SUBJECT LAND: 100-120 King Street and 30-36 Dangar Street, RANDWICK NSW 2031.
APPLICATION NO: MP09_0188 MOD 2
PROPOSAL: Modification Request to the Concept Approval for expansion of the existing aged care facility at the Sir Moses Montefiore Jewish Home.

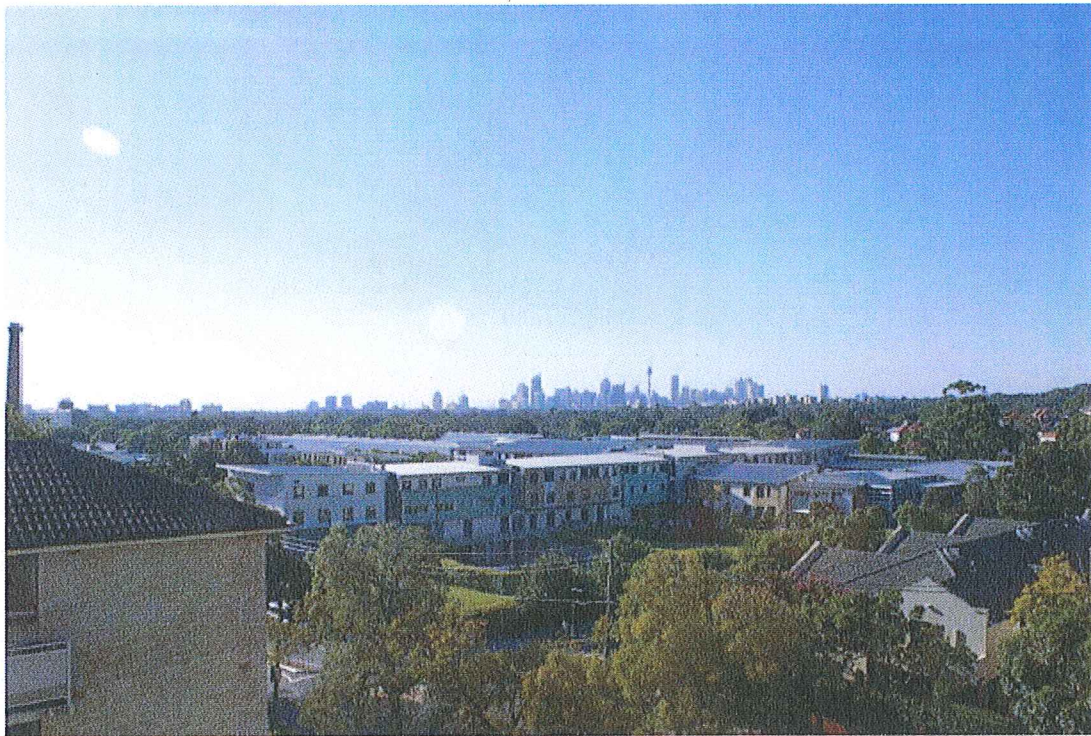
- The additional landscape details from Oculus Landscape Architects are noted. However, while these details confirm the ability to provide established landscaping in the new "open space corridors" especially between Buildings C, E and F, the proposed landscaping is not considered capable of satisfactorily softening the additional accentuated height and massing on Building E even where the proposed landscaping is at an established mature stage. For example, based on Section A in the Oculus plan, the established trees are estimated to reach a maximum of approximately RL50, compared to the maximum height of RL64.8 for Building E. It should be noted that the building envelope for Building E in the Oculus plan (as well as all other buildings in the plan) is figurative as it

does not show the impact of elevated basement levels (thus depicting the building as lower) and does not give accurate heights to AHD / RL.
